Serial No. 10/721,179
Amdt. Dated November 16, 2004
Reply to Office Action of August 18, 2004

Docket No. K-0586

REMARKS/ARGUMENTS

FIG. 3

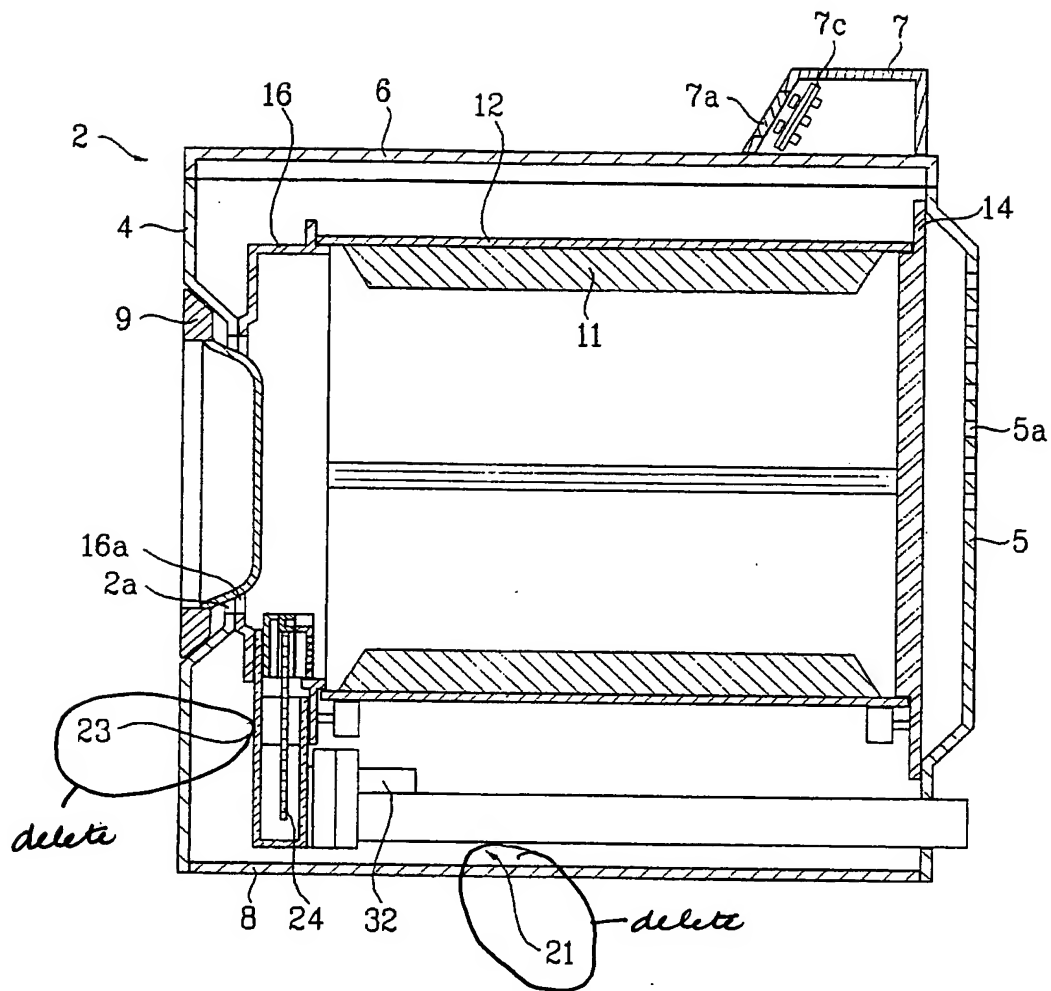
The Office Action objects to the drawings under 37 C.F.R. § 1.83a, asserting that the plurality of coils provided at top and bottom points of the first and second coil arrays are not shown in the drawings. Claims 5 and 14 have been amended to recite, *inter alia*, a plurality of coils provided at upper and lower portions of each coil array. The Examiner's attention is drawn, for example, to Figure 3 of the present application, which shows a plurality of coils provided at upper and lower portions of each coil array. More specifically, first coils 61, 63, and 65 are positioned at an upper portion of the first coil array 60, and first coils 62, 64, and 66 are positioned at a lower portion of the first coil array 60. Likewise, second coils 72, 74, and 76 are positioned at an upper portion of the second coil array 70, and second coils 71, 73, and 75 are positioned at a lower portion of the second coil array 70. See also, for example, paragraph 44 of the present application.

The Office Action further asserts that the top and bottom points being on center lines of the upper and lower passages, respectively, is not shown in the drawings. Claims 6 and 15 have been amended to recite, *inter alia*, upper and lower portions lie on centerlines of the upper and lower passages, respectively. Again, the Examiner's attention is drawn, for example, to Figure 3 of the present application, which shows first and second coils 61, 63, 65, 72, 74, and 76, respectively, along what is substantially the center line of the upper passage 53a, and first and

The Office Action further asserts that the drawings do not show a predetermined distance between the coils of the first coil array 60 and the coils of the second coil array 70. Again, the Examiner's attention is drawn, for example, to Figure 3 of the present application, which clearly shows the first coils 61, 63, and 65 and second coils 72, 74, and 76 at a predetermined distance from corresponding coils 71, 73, 75, 62, 64, and 66, respectively. Further, Figure 3 clearly shows coils 61, 72, 63, 74, 65, and 76 positioned at a predetermined interval in the upper passage 53a, and coils 71, 62, 73, 64, 75, and 66 positioned at a predetermined interval along the lower passage 53b. See also, for example, paragraphs 43-44 of the present application.

The attached drawings include changes to Figures 2-3. These sheets, which include Figures 2-3, replace the original sheets including Figures 2-3. In Figure 2, reference numbers 21 and 23 have been deleted. In Figure 3, reference number 21 has been deleted.
